# PlanGrid Task Report - Sep 6, 2024

Prepared by Ian Fuller

14 tasks in this report.

## #363 [CNTL 107] (MISC) Units are not wired for occupancy

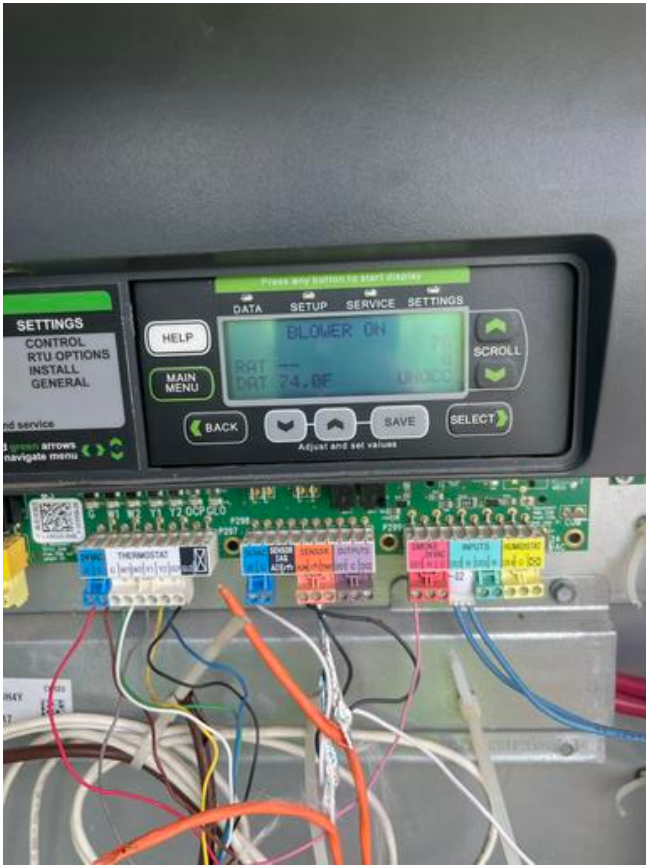
Units are currently not wired for occupancy. Jumper between P1 and R with occupancy wire ran from P.
